NL-14-046

SUBJECT: Response to Request for Additional Information Regarding Containment Integrity Analysis (TAC NOS. MF0590 and MF0591)
Indian Point Unit Numbers 2 and 3
Docket Nos. 50-247 and 50-286
License Nos. DPR-26 and DPR-64

**RESPONSE TO REQUEST FOR ADDITIONAL INFORMATION
REGARDING CONTAINMENT INTEGRITY ANALYSIS**

**ENTERGY NUCLEAR OPERATIONS, INC.
INDIAN POINT NUCLEAR GENERATING UNIT NOs. 2 and 3
DOCKET NOs. 50-247 and 50-286**

Figure
INDIAN POINT UNIT 2 DOUBLE ENDED PUMP SUCTION BREAK
SENSITIVITY TO INITIAL AIR TEMPERATURE

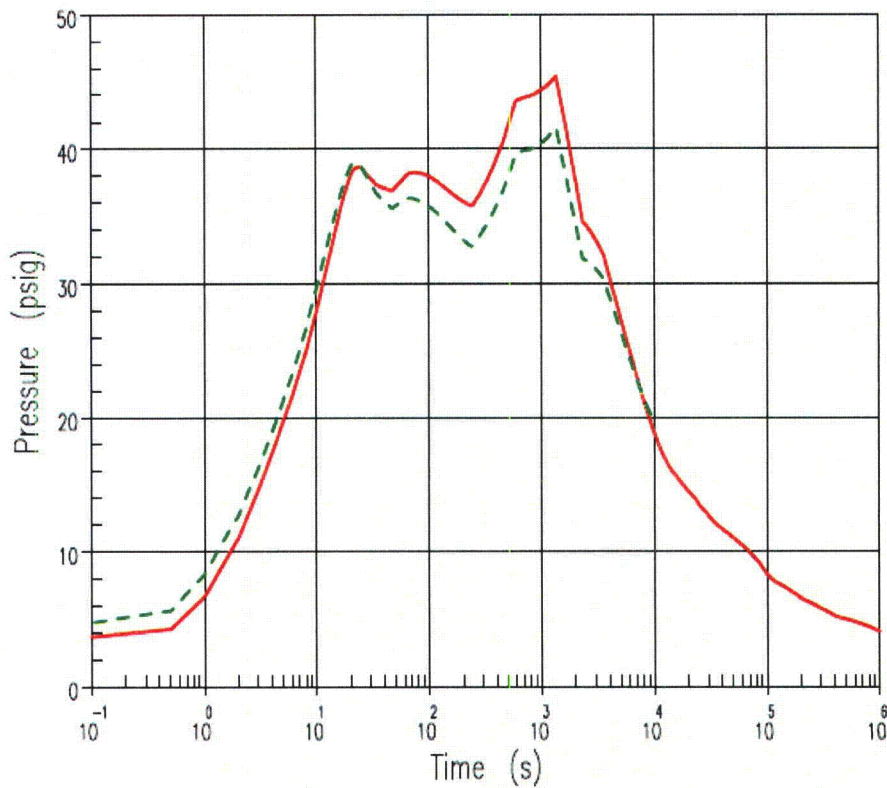
TS LCO 3.6.5 for both Indian Point Units 2 and 3 specify the range of containment air temperature during Modes 1 through 4 between 50°F and 130°F. In support of a recent license amendment request, sensitivity analysis performed by a licensee for the peak containment pressure during a large break LOCA with respect to the initial containment air temperature indicated that the peak containment pressure is greater when using an initial containment temperature less than the maximum TS allowable due to the effect of higher density of non-condensable at the lower temperature. In that case, the effect of using the initial containment air temperature of 98°F versus the maximum TS value of 135°F increased the peak containment pressure by 1.3 psi. The same is also possible for Indian Point Units 2 and 3 because a higher density of non-condensable at 50°F would have a greater mass compared to the same at 130°F, and therefore may result in a higher peak containment pressure. Please provide results of large break LOCA peak containment pressures, including pressure profiles, for initial containment air temperatures of 50°F and 130°F while assuming the remaining input parameters and assumptions remain the same in both cases.

In response to the above RAI, Westinghouse was contracted to perform a sensitivity study on the impact to peak containment pressure with containment initial temperatures of 50°F and 130°F. With respect to peak containment pressure, both Indian Point Units are limited by the double ended pump suction break (DEPS) with minimum ECCS and containment safeguards in operation. Thus, only the DEPS break was reanalyzed for IP2 for the lower initial containment temperature. The two cases analyzed are:

The results are shown in the Table below, and a comparison of the pressure profiles are shown in the Figure on the next page. A significant reduction (>3 psi) in peak containment pressure is attained with the lower initial containment temperature. For the DEPS break, the peak pressure occurs in the post-reflood period. Consequently, while the colder initial air temperature does contribute to a higher air partial pressure as seen in the Figure, this is more than offset by the colder heat sinks, which are able to absorb a greater amount of heat over the long-term transient. A similar result would be expected for IP3. Further, the sensitivity study included additional conservatisms by assuming the accumulator water temperature remained at 130°F, and the Refueling Water Storage Tank and Service Water temperatures remained at the TS maximum allowable value. Lower temperatures for these parameters would enhance the performance of the containment spray system and the fan cooler units. This would result in an even lower peak containment pressure.

INDIAN POINT UNIT 2 – SENSITIVITY TO INITIAL AIR AND CONTAINMENT STRUCTURAL TEMPERATURE ASSUMED IN THE LOCA CONTAINMENT INTEGRITY ANALYSIS		
Break Location	Air at 130°F/Structures at 130°F (Design case)	Air at 50°F/Structures at 50°F (Sensitivity study)
Double Ended Pump Suction (DEPS) Break with Minimum ECCS flows	45.44 psig at 1365 seconds	41.58 psig at 1369.9 seconds
